STAFF REPORT TO THE PLANNING AND ZONING COMMISSION

SUBJECT: Major Commercial Site Plan – United Dairy Farmers, 303 W Granville St.

DATE: December 17th, 2025

Figure 2: Site Plan

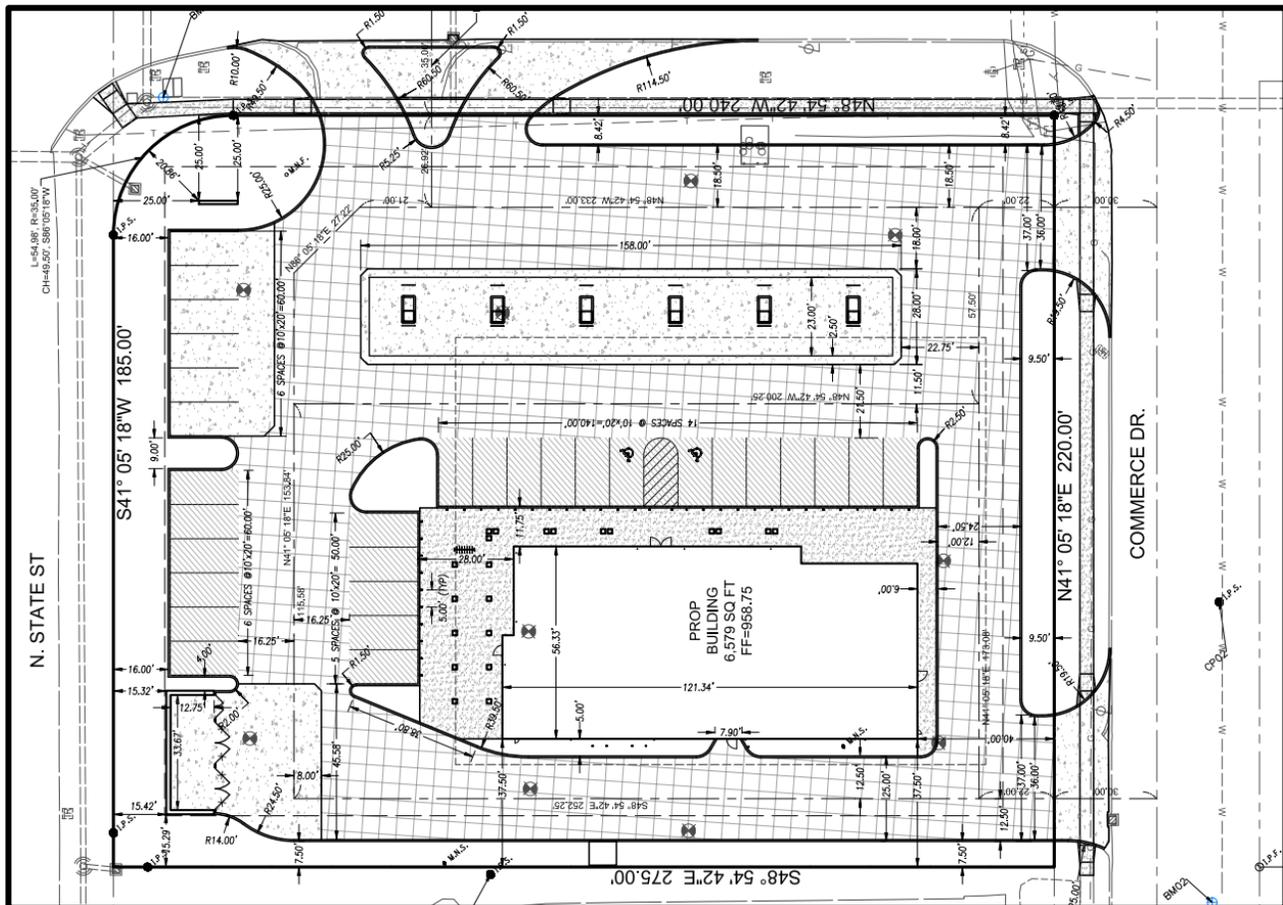
2. The site plan complies with most of the setback requirements, with a couple exceptions.
 - a. Our zoning ordinances state that there needs to be an area of 20' for a side yard that cannot be used for accessory buildings, outdoor storage, or parking, and must be paved with a minimum of 8" of firmly packed crushed stone. As this is a Planned District, I looked at the adjacent parcels and other parcels in this district, none of which meet this requirement. I believe that this restriction was removed from the zoning text in the planned development text, but we cannot verify as we were unable to locate the text prior to this meeting.

- b. There is a requirement for the building to be setback 65' to the adjacent road or street right-of-way. On the southeast side of the site along Commerce Drive, the distance from the proposed building to the right-of-way of the adjacent road is around 55'. There is one other example of a building setback being less than 65' on Commerce Drive, which is the EMS Station, shown below with a setback of about 50'.

5. Using the following calculations, the total required parking spaces for this site would be thirty-six (36) plus the number of employees. The site plan shows thirty (30) spaces, which would not meet the minimum requirement.

- a. Gas Stations: One (1) parking space per two (2) gas pumps, plus one (1) per employee
 - i. Six (6) pumps = 3 parking spaces
 - b. Retail Establishments: One (1) space per 200 square feet

- i. 6,579 square feet = 33 parking spaces
6. Comprehensive Plan
 - a. The 2016 Sunbury Comprehensive Plan does not directly talk about this parcel or those around it. As this is the same use that existed when the plan was approved, and there are no recommendations for this area in the plan, I believe that the new site plan would be consistent with the 2016 Sunbury Comprehensive Plan.

7. On driveways and parking lot access roads, our zoning code states the following:
 - a. “Driveway and access road locations shall be approved by the City Engineer to ensure a suitable distance is provided from adjacent public streets and other driveways.”
With this, the right-in/right-out access off W Granville Street would be subject to engineering review per code, which would allow approval contingent on our engineering review of this access point.

8. Staff would recommend this commercial site plan for approval contingent on final engineering and stormwater. This site plan remains consistent with what currently exists on the parcel, while improving architectural quality and appearance, landscaping, pedestrian connectivity, and site arrangement.

Figure 3: Dumpster Elevation from the West

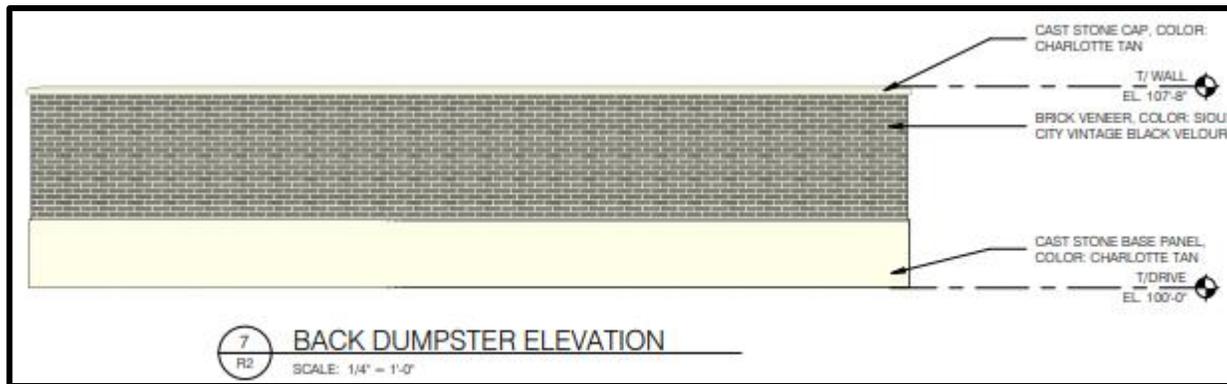
4. The site plan complies with our screening requirements. The dumpster screening is required to be a minimum 6’ wall, fence, or shrubbery, and the plan shows both a 7’- 8” wall surrounding the dumpster and arborvitae and switchgrass screening the wall itself from State Route 3. In addition, the off-street parking is screened from all public streets per the landscape plan.
